ADDENDUM #02
EA-3

JEFFERSON COUNTY
LAW ENFORCEMENT CENTER
JEFFERSON, WISCONSIN

SECOND FLOOR PLAN
COURTHOUSE
LIGHTING

E-4

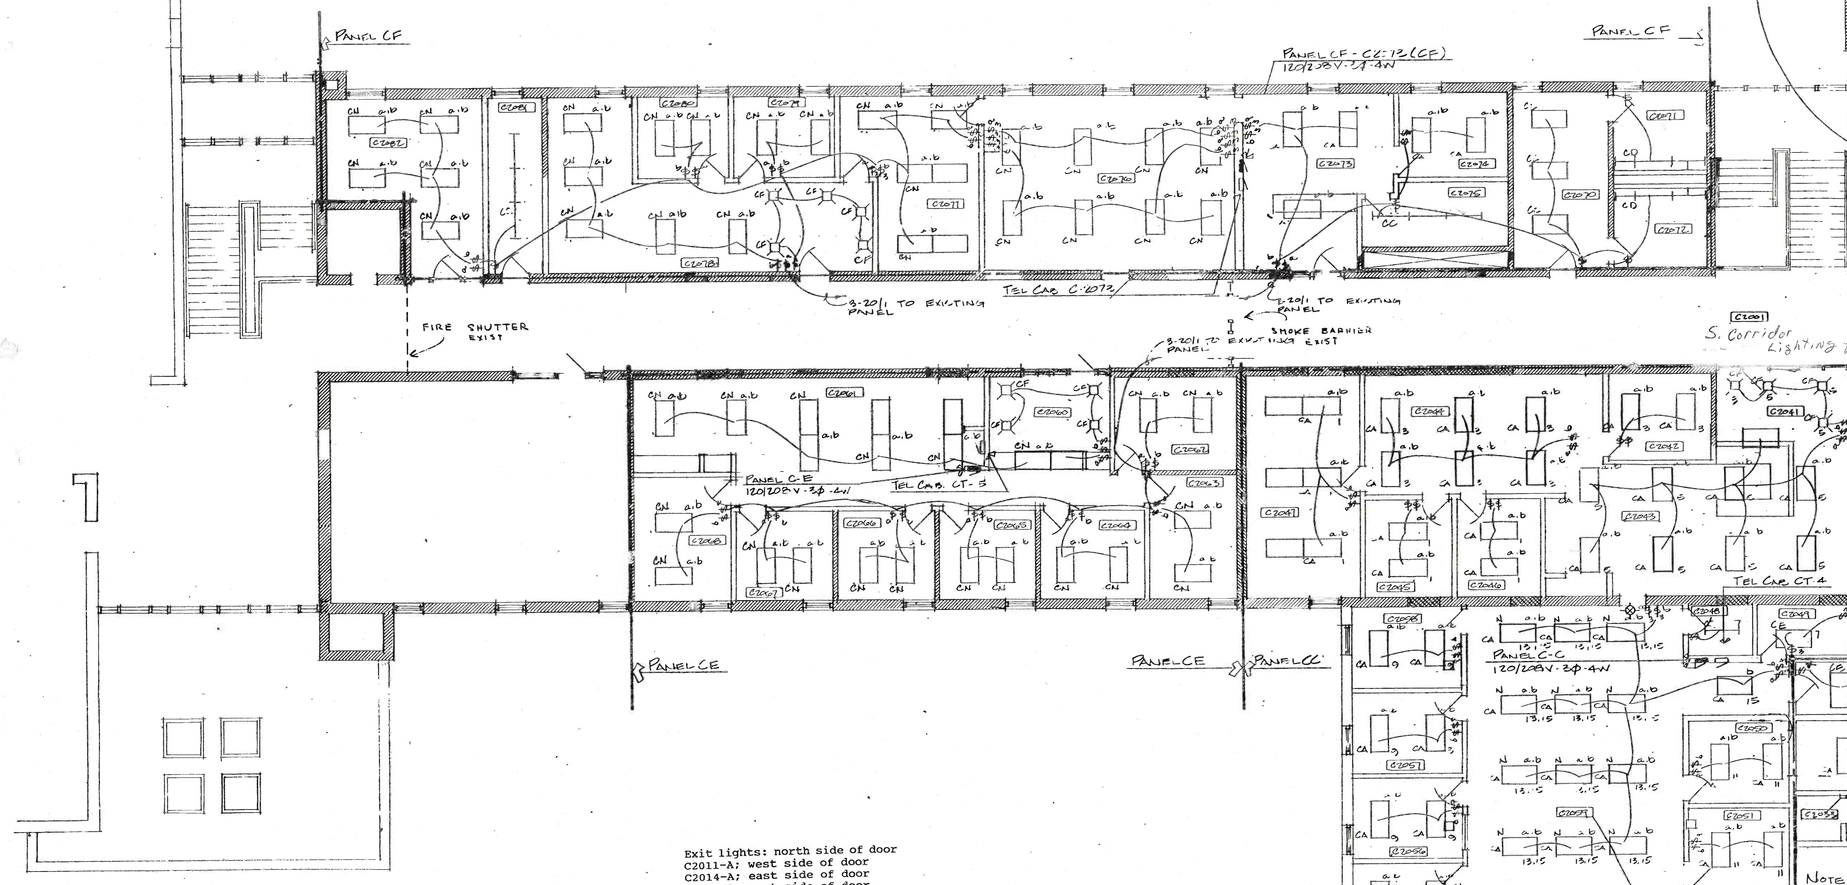
Exit lights: north side of door C2011-A; west side of door C2014-A; east side of door C2014-D; east side of door C2028-A; west side of door C2028-B and C2028-C; north side of door C2059-A

NOTE: New Courthouse exit lights are to be tied into existing courthouse exit light circuit.

1. C2002 - See Sheet ER-3 for new lighting layout.
2. C2003 - See Sheet ER-3 for new lighting layout.
3. C2012 - See Sheet ER-3 for new lighting layout.
4. C2013 - See Sheet ER-3 for new lighting layout.

5. C2014-1 - See Sheet ER-3 for new lighting layout.
6. C2025 - Delete 2 'CA' fixtures. Provide 2 'CE' fixtures.
7. C2004 - Provide 4 'CE' fixtures, circuit to existing panel.

8. C2031 - Delete 3 'CA' fixtures, 1 from each 2 fixture row.
9. 2034 and 2035 - See Sheet ER-4 for new lighting layout.
10. Add two (2) 'CL' fixtures in Room C2011 4' 0" off East wall. One (1) fixture 4' 0" off North wall to center and one (1) fixture 6' 0" South to center. Fixtures to be flange type.

11. Add exit light at top of stair C2010 in Room C2011.
12. Add exit light in Room C2004 at door to Room C2011.
13. Add exit light with directional arrow at South end of Room C2001.

14. Add exit light with double face and directional arrows at intersection of Rooms C2030 and C2040.
